# INNER WEST

## DEVELOPMENT ASSESSMENT REPORT

<b>Application No.</b>	DA/2020/0273
<b>Address</b>	37 Spencer Street SUMMER HILL NSW 2130
<b>Proposal</b>	Removal of street tree and construction of driveway
<b>Date of Lodgement</b>	20 April 2020
<b>Applicant</b>	Mr Zouhair Barakat
<b>Owner</b>	Ms Lynda Barakat
<b>Number of Submissions</b>	13
<b>Value of works</b>	\$10,000.00
<b>Reason for determination at Planning Panel</b>	Number of submissions
<b>Main Issues</b>	Tree management, parking & landscaped area.
<b>Recommendation</b>	Refusal
<b>Attachment A</b>	Reasons for refusal
<b>Attachment B</b>	Plans of proposed development
<b>Attachment C</b>	Draft conditions in the circumstance the application is approved

SITE PLAN 1:200

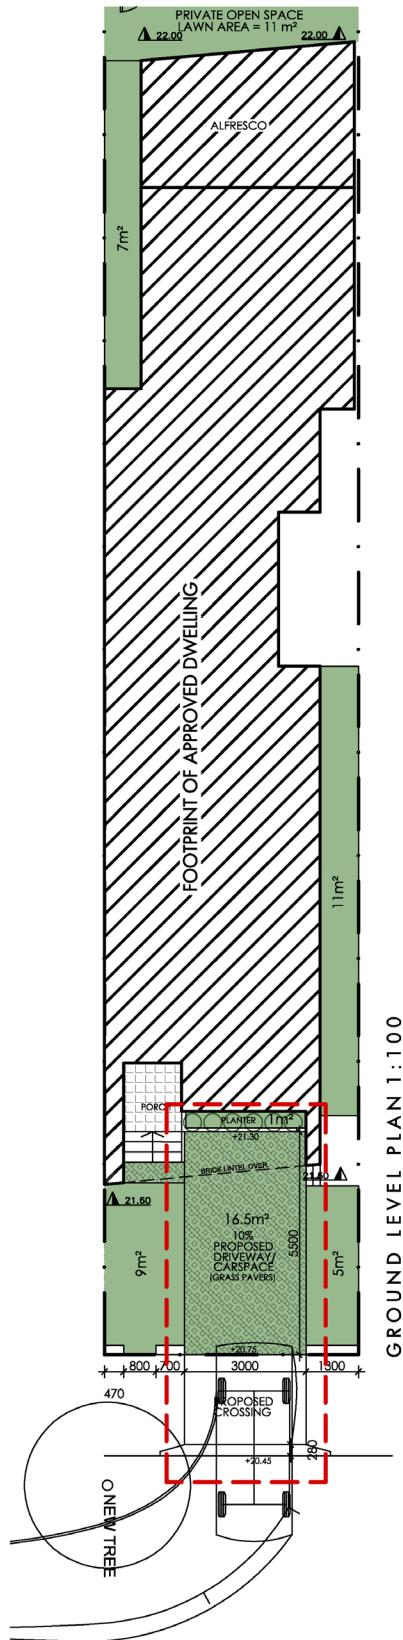
- The proposed location of the replacement tree is in front of a power pole that supports several service wires that would impede the canopy of a new tree;
- The proposed parking space is forward of the building line and would result in a poor outcome for the streetscape;
- The proposed driveway and replacement planting would result in the loss of on-street parking; and
- The proposed parking space would reduce the amount of landscaped area on the site and within the front garden to less than the minimum required area.

DS6.4 of Chapter F, Part 1 of CIWDCP 2016 requires car spaces between the front boundary and forward building line only where a sufficient amount of front landscape garden area is provided. As a result of the parking space, 41.2sqm, being 17.6% of the site, will be landscaped area. DS8.1 of Chapter F, Part 1 of CIWDCP 2016 requires 25% of the site be landscaped area. The pervious pavers below the parking space are not included in the landscaped area as they are not capable of deep soil planting. In addition, DS6.7 of Chapter F, Part 1 of CIWDCP 2016 does not permit the removal of existing streets to enable a driveway to a dwelling house.

The application seeks to vary the above controls by relying on a precedent of parking forward of the building line in the surrounding area. All parking spaces and driveways in the surrounding area are associated with a parking structure behind the forward building line in accordance with Council’s controls. As such, it is considered that there is no precedent in the

street for car spaces forward of the building line. It is considered that the proposed parking space will have a detrimental impact on the surrounding streetscape.

2. Construction of a driveway and hard stand parking space between the front boundary and forward building line will result in an unacceptable impact to the streetscape and loss of landscaped area and do not comply with Chapter F, Part 1 of the Comprehensive Inner West Development Control Plan 2016.

DEEP SOIL PLAN 1:100  
LANDSCAPE PLAN 1:200

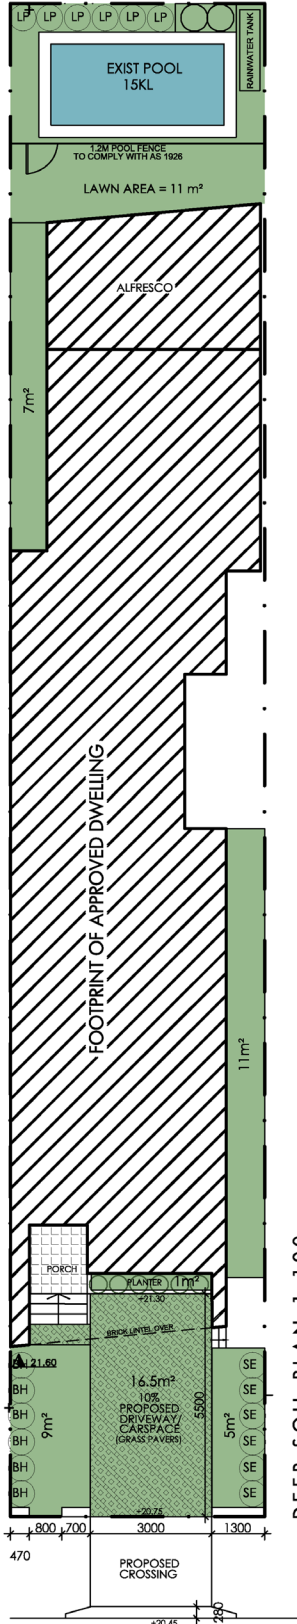
Chapter C, Part 6 of CIWDCP 2016 requires Council to determine the appropriateness of proposed plantings based on consideration of the species, size, location on the site, proximity to surrounding structures and site constraints. It is considered that there are no locations appropriate for a replacement tree adjacent to the site given the proximity of the power poles and wires which will impede the future growth of the tree.
